CLEAN II
Interoffice Memorandum

Subject: Meeting Minutes for the Progress Meeting
Phase II RI/FS Work Plans
MCAS El Toro, CTO-059

Date: 28 October 1994

Phase 1
Figure _
Site 2

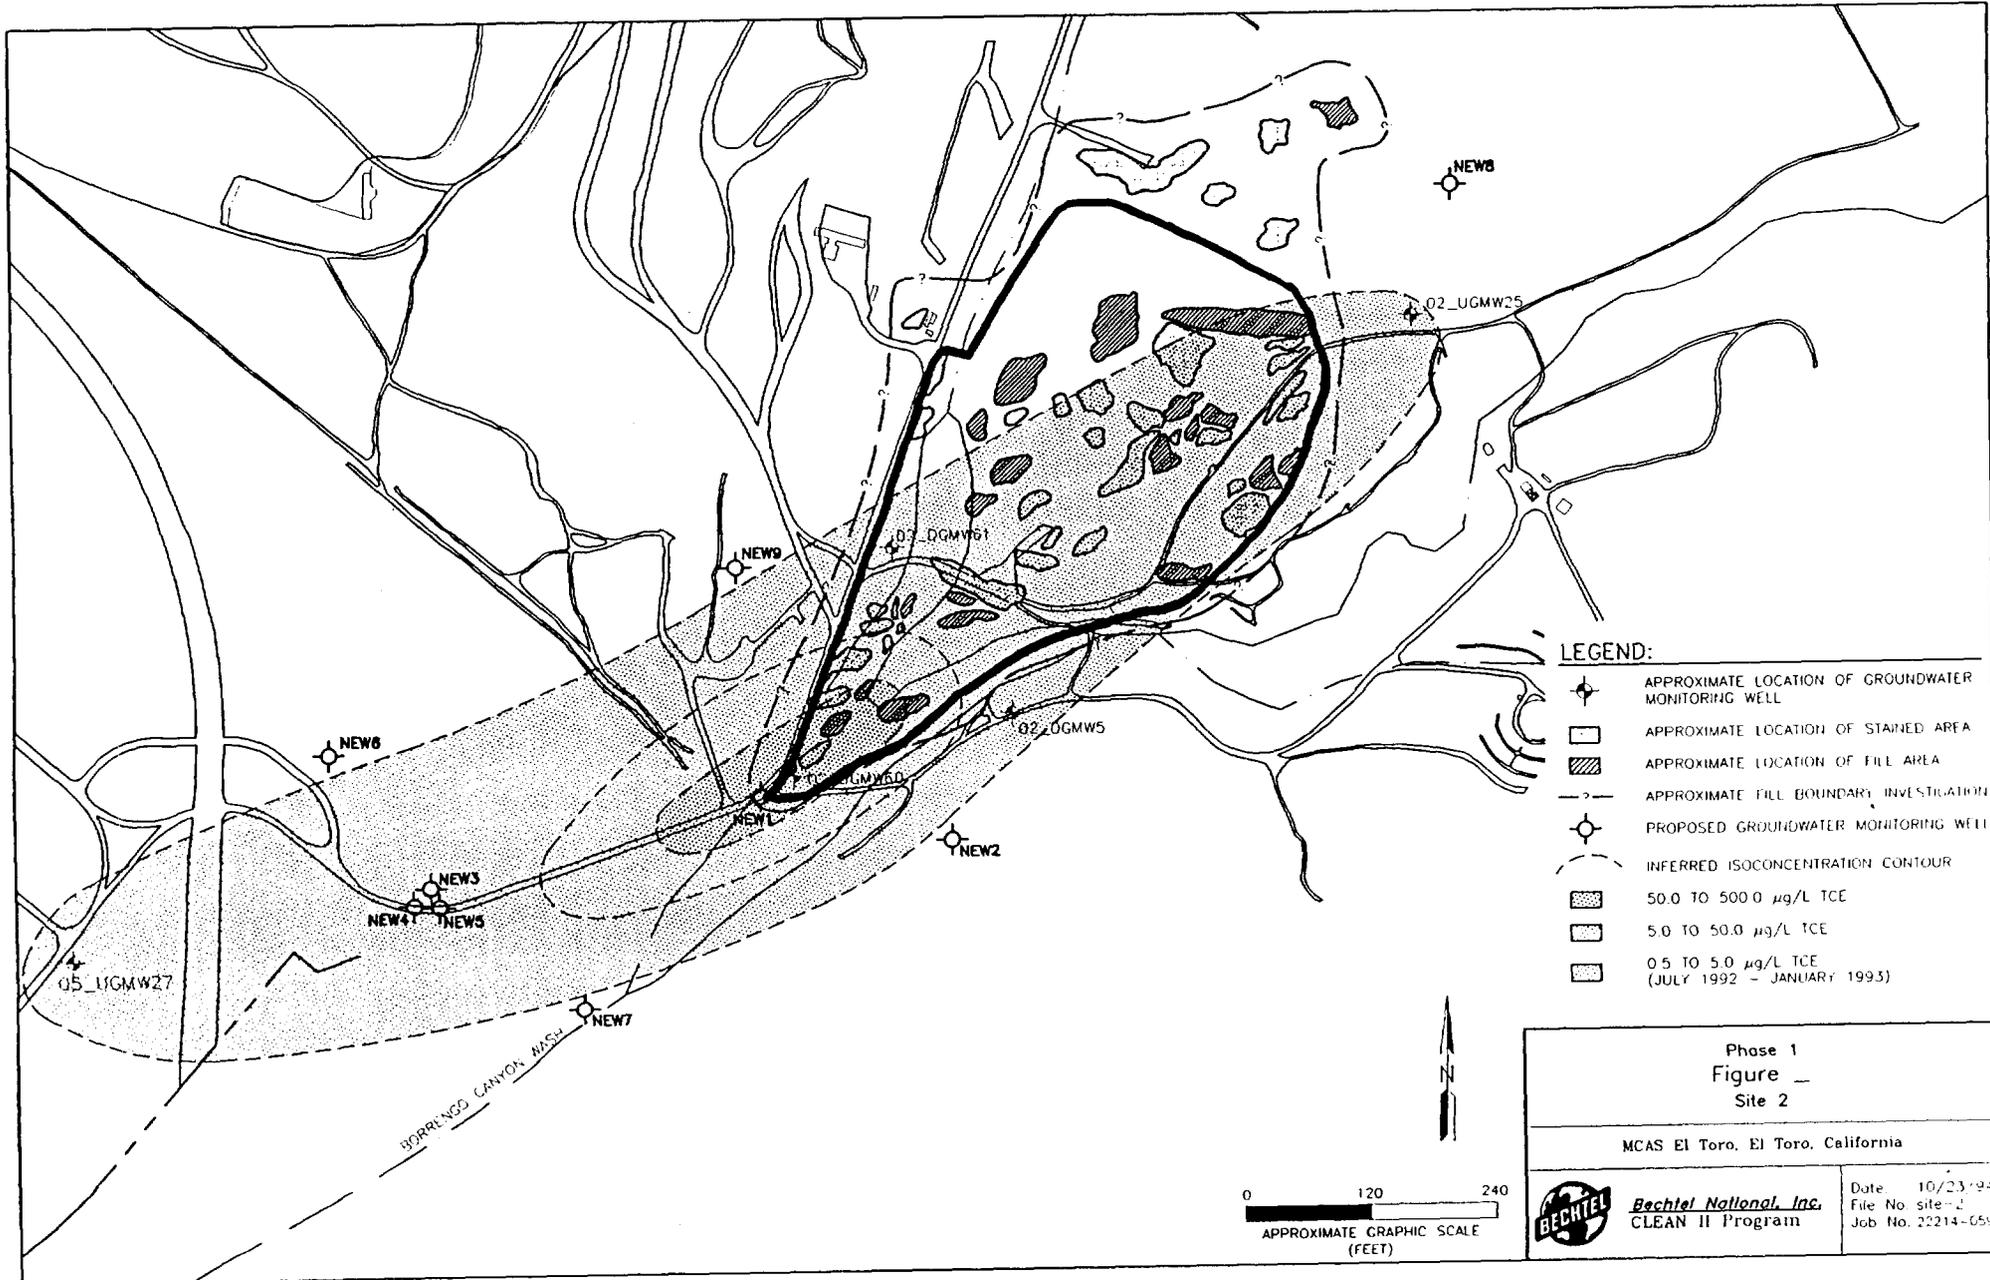
1. At the beginning of the presentation, Tim Latas emphasized the use of the tiered approach for the Work Plan and the associated Phase II investigations. Sherrill Beard agreed that the tiered approach was a good format to follow.

2. Bonnie Arthur questioned if there was a mechanism in place to notify the regulators of the events occurring in the field. Ms. Arthur mentioned a form that had been used for other projects. It was stated that the contractors can fill out this form at the conclusion of each week of field work and then FAX the information to the associated regulators. It was agreed that these weekly notifications, or field variances, would be extremely helpful. Dave Cowser mentioned the possibility of having weekly field meetings on site to discuss that past week of field work as well as the upcoming week's events.

3. While discussing drilling the proposed borings and monitoring wells, Chuck Elliott emphasized that these borings and wells would need to be drilled extremely deep to get the data proposed.

4. During the discussion regarding the possible components of concern, John Broderick mentioned that Vinyl Chloride may be present. Jerry Jackson agreed stating that it would be logical to look for it. Stacy Wissler commented that several of the types of analytical tests involved in this investigation could be performed in a mobile laboratory.

5. A discussion ensued regarding Stratum 2. Bonnie Arthur questioned why it had been identified separately from the landfill. Chuck Elliott responded that it had only be discovered through aerial photographs and recommended to be studied in Phase II. Other new discoveries identified at the south of the site had been incorporated in the landfill, but parts of the north end of the landfill had not yet been identified. Joe Zarnoch stated that it is significant to assess these areas and determine if they are to be part of the landfill. John Broderick mentioned that some of these areas may have been caused due to a flood in the area. Katrina Lyons reiterated that these areas would be investigated. Bonnie Arthur mentioned that it is important to limit the boundaries of the landfill. Jerry Jackson agreed but commented that the limits of the study may not necessarily be the limits of the landfill.

6. A discussion ensued regarding the possibility of trenching. Katrina Lyons stated that the surface geophysics and trenching will be performed when necessary in order to determine the limits of the landfill. If it is necessary, further investigations will be performed in hot spot areas.

Phase 1 Figure — Site 3	
MCAS El Toro, El Toro, California	
	Bechtel National, Inc. CLEAN II Program
Date 10/22/94 File No. site-3 Job No. 22214-059

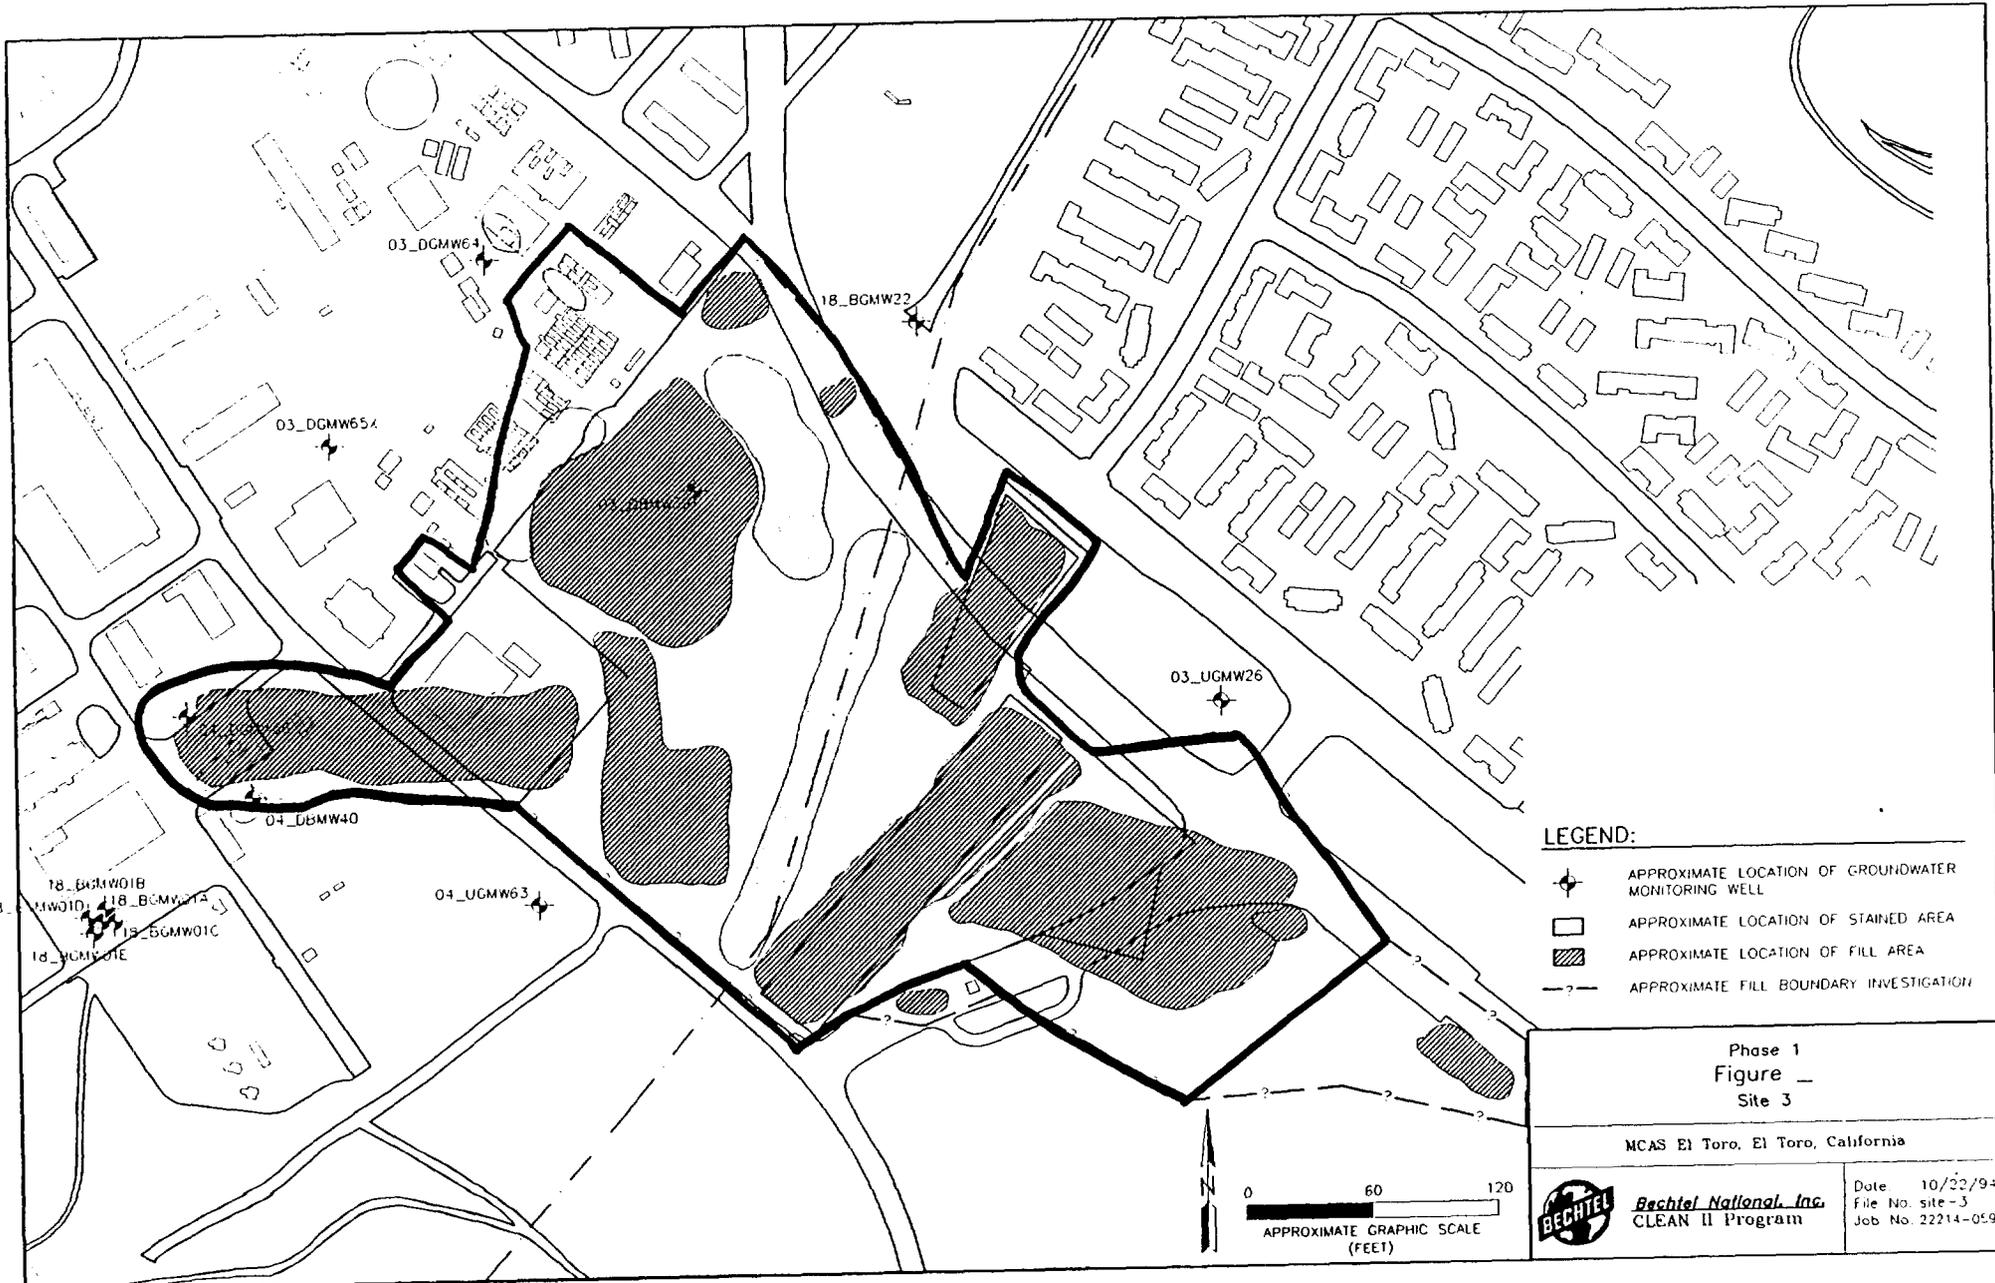
1. Yueh Chuang stated that he thought another cluster of downgradient wells were necessary. This is due to the proximity of the tank farm and attempts to determine if the tank farm or the landfill is responsible for the possible groundwater contamination. John Broderick questioned if it was part of this study to include downgradient well coverage to differentiate between the landfill and the tank farm. The discussion continued and questions and responses regarding the contamination in the groundwater and the necessity of distinguishing between the two sites was debated. Ginny Garelick thought it was only necessary to discuss the landfill for this project. If the tank farm is an issue, Mr. Garelick stated that it should be an issue to be addressed by the BCP. She also stated that this had been decided previously, that this problem was associated with and to be handled by the tank farm. Tim Latas questioned what the plans for Tank 398 are. It was commented that it had been removed and the project to start working on the plans for remedial action had begun.

3. Bonnie Arthur stated that she thought it would be necessary to assess wells 64 and 65 during Tier 1. If contamination is detected, then she would like a well to be installed farther away from the site to discern horizontal as well as shallow groundwater contamination. Katrina Lyons agreed and stated that this would be incorporated in the Work Plan.

4. Joe Zarnoch stated that he did not think it was necessary to install additional wells to assess shallow groundwater. He commented that he thought vertical delineation of groundwater contamination would be more significant. For this, he thought an additional downgradient well cluster would be necessary. The discussion regarding the purpose of the wells (for the landfill or for the tank farm) resumed. Jerry Jackson stated that when the water levels are taken, the groundwater gradient can be determined and then it would be possible to discern if downgradient wells associated with the landfill are necessary.

5. John Broderick voiced a concern with the use of a soil gas survey over the entire landfill. He mentioned that this is the oldest landfill on the base and that it may not have volatiles any more. Katrina Lyons commented that the soil gas information would also be used to determine where to install the slant boring. Chuck Elliott stated that CH2MHill did propose a soil gas survey for the entire landfill to collect necessary data for closure. Ms. Lyons stated that the current proposed soil gas survey was for a 75 foot grid. John Broderick stated that he thought a smaller soil gas survey grid would be acceptable. Joe Zarnoch stated that it would be necessary to have soil gas information from the incinerator area. John Broderick agreed and stated that regulations are

7. Joe Zarnoch stated he thought additional soil samples from the incinerators area would be necessary, but that Bonnie Arthur should talk to the EPA toxicologist. However, it was mentioned that additional soil samples may not be necessary depending on how the deed restriction is written. It was agreed that there are many unknown areas in Site 3 and that it should be investigated with the deed restriction in mind.

9. Bonnie Arthur requested to discuss the vertical extent of contamination and are monitoring wells necessary for this. Tim Latas stated that this may be warranted as contamination was detected at great depths. Joe Zarnoch stated that the contamination found at such levels was primarily fuel contamination. Jerry Jackson and Chuck Elliott agreed that it was strange to be so deep, however it was stated that this area is in a recharge zone with a very steep downward gradient. This could result in a very large smear zone, which could be a large problem. Tim Latas stated that if there is a smear zone, then contamination would be detected at shallow groundwater depths, which it was confirmed that there is contamination at shallower depths in groundwater.

Phase 1 Figure _ Site 5	
MCAS El Toro, El Tota, California	
	Date: 10/22/94 File No site-5 Job No 22214-053
Bechtel National, Inc. CLEAN II Program

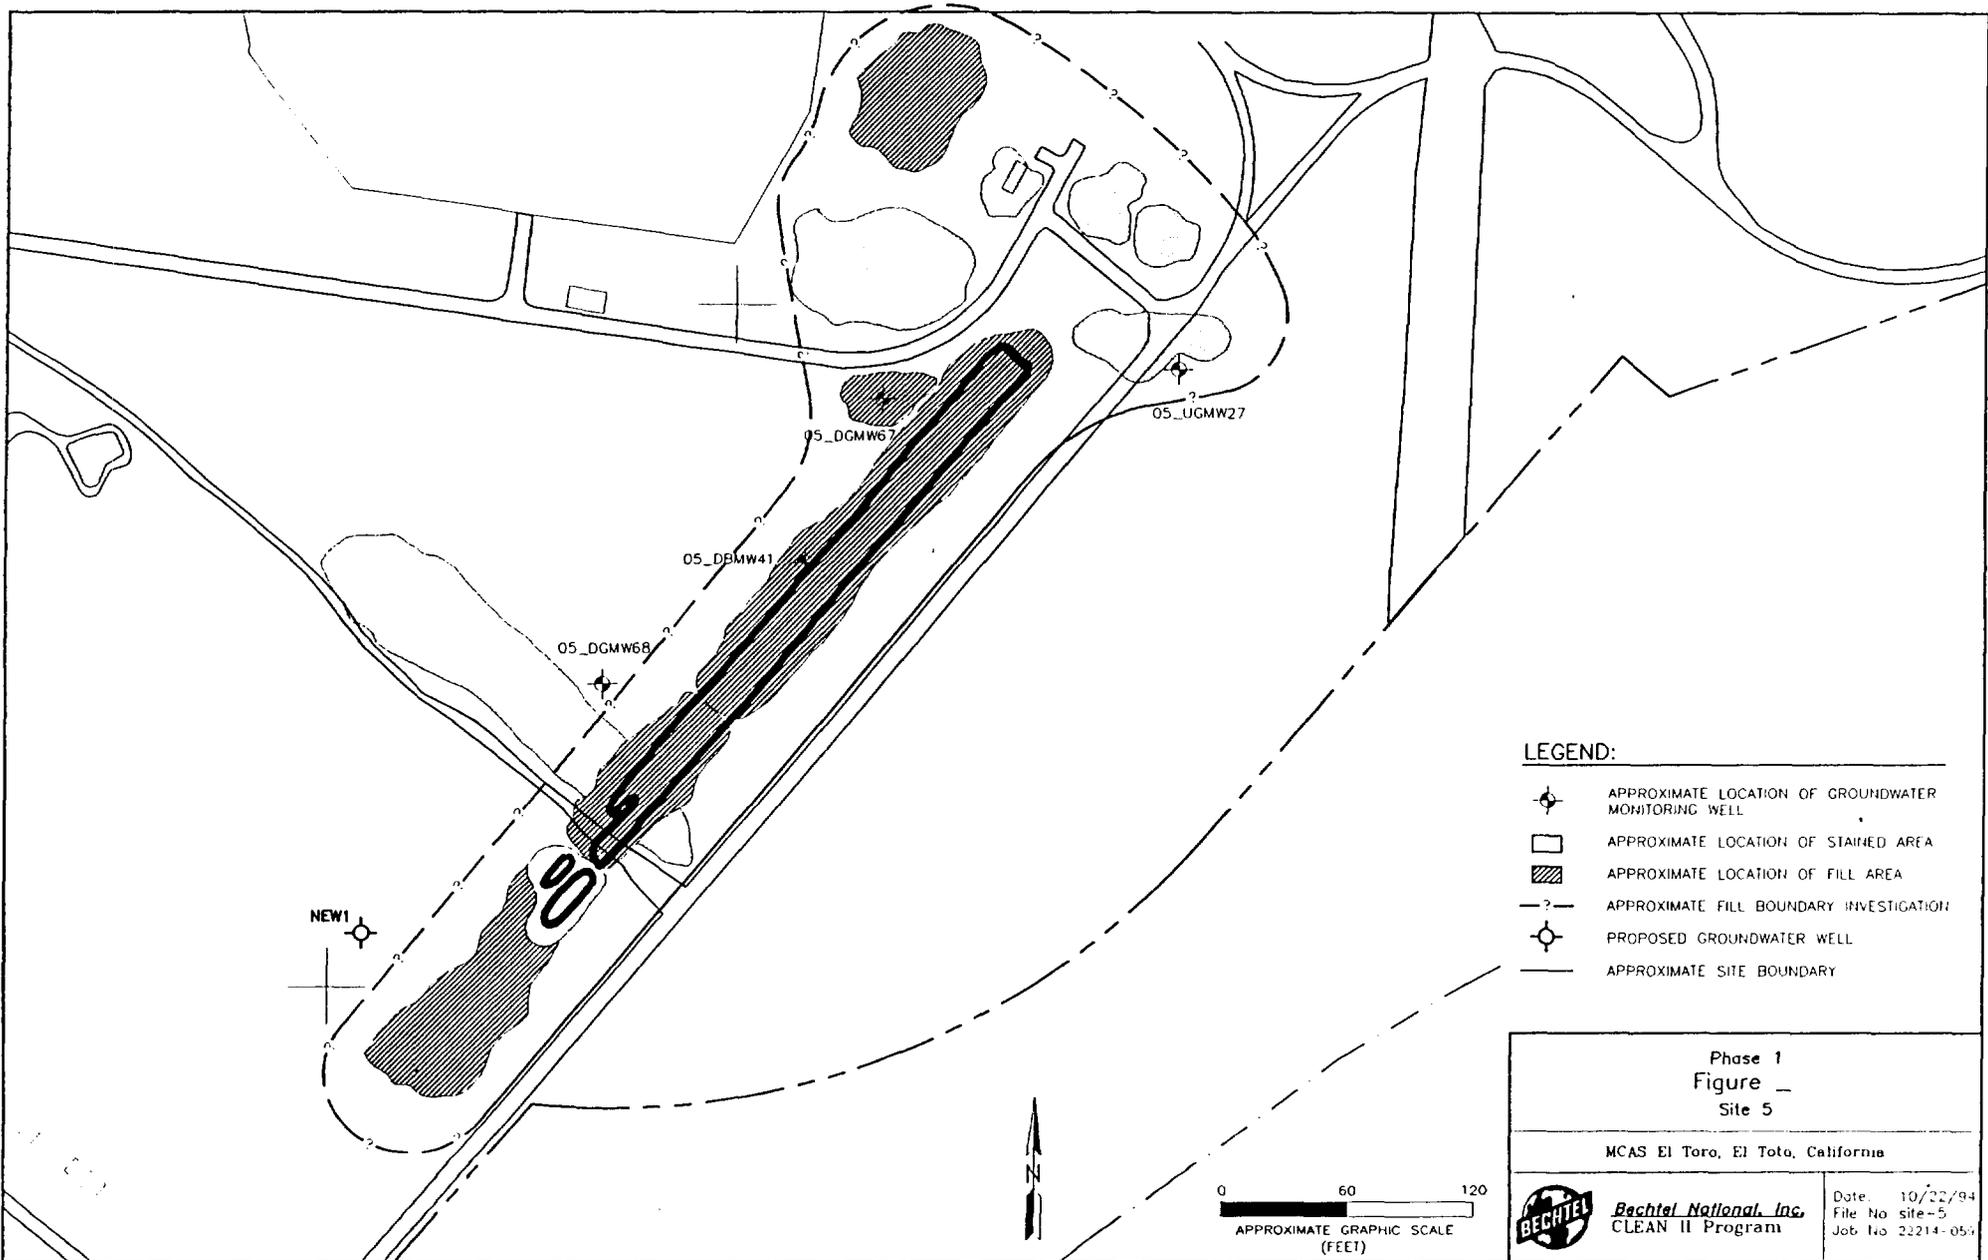
1. John Broderick mentioned that it was revealed from the interviews with individuals who had worked at the landfill, that the landfill is actually much deeper than expected, possibly 40 feet deep.

2. Yueh Chuang stated that field screening should notice high hits of contaminants at approximately 15 to 25 feet; this was the depth at which CH2MHill experienced several high hits.

4. Chuck Elliott commented on the new well proposed by the CLEAN II Team. He stated that the well proposed by CH2MHill had been for regional coverage. Ginny Garelick questioned if there is a listing of all wells which were for regional coverage. Chuck Elliott replied that these wells were primarily those downgradient of sites 2, 3, 5, and also a well halfway between Sites 13 and 16. Wells surrounding Site 17 are also included. Ms. Garelick requested a map from CH2MHill illustrating wells proposed for regional coverage and are now intended for OU-1.
